ADDENDUM NO. 1

RE: Item #1, June 4, 2025 Letting - BRO-B 8062(10), PCN 08NA, Tripp County - Structure (3-9x6 CIP RCBC) & Approach Grading

PLANS: Please destroy sheets 2, 17, and 25 and replace with the enclosed sheets, dated 5/16/25.

SHEET
NO.
17

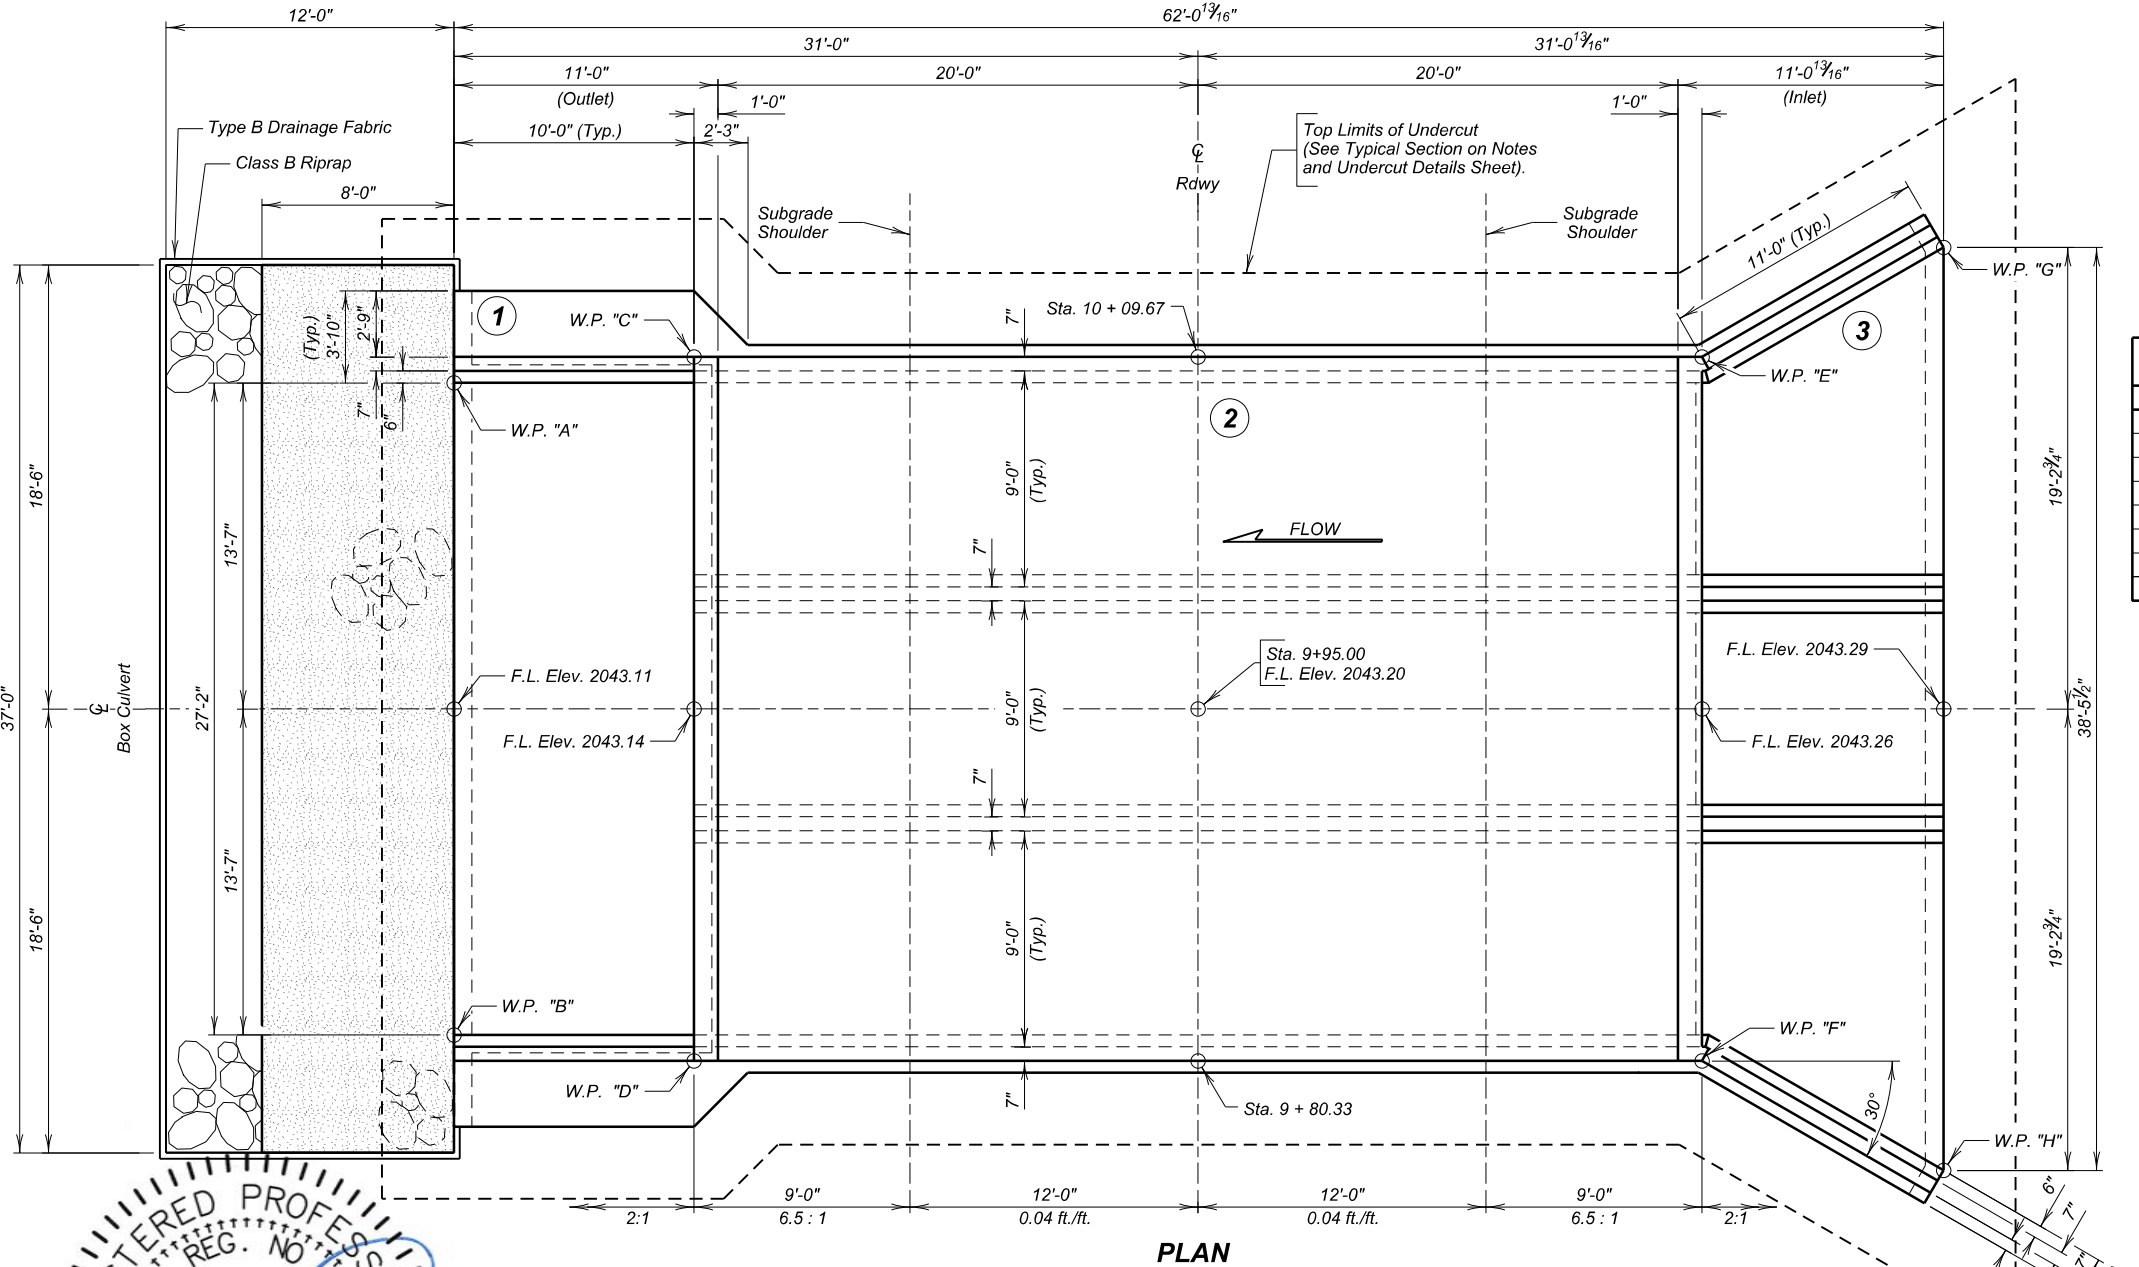
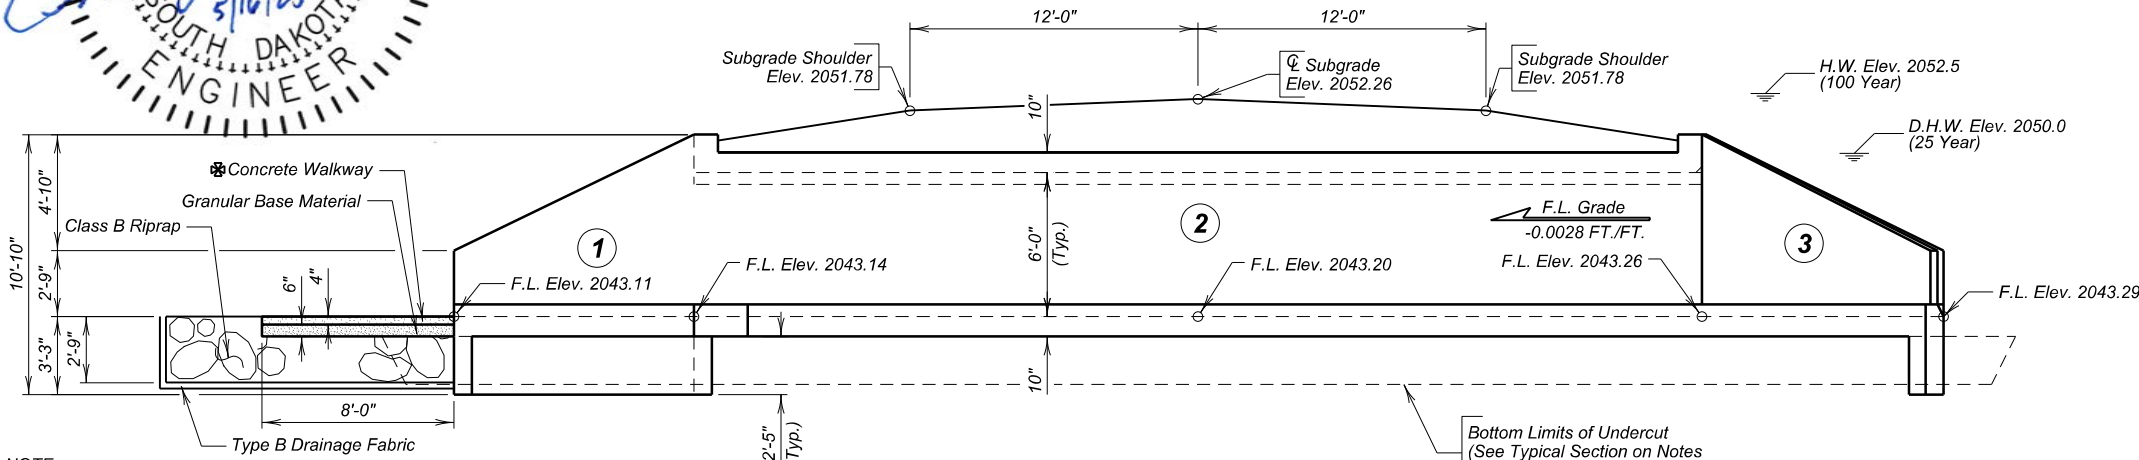
Sheets 17 & 25: ESTIMATED QUANTITIES was revised

ITEM	UNIT	QUANTITY
Incidental Work, Structure	L.S.	L.S.
Structure Excavation, Box Culvert	Cu. Yd.	67
Box Culvert Undercut	Cu. Yd.	188
Class A45 Concrete, Box Culvert	Cu. Yd.	140.1
Class M6 Concrete	Cu. Yd.	3.7
Reinforcing Steel	Lb.	18402
Class B Riprap	Ton	63.3
Type B Drainage Fabric	Sq. Yd.	80
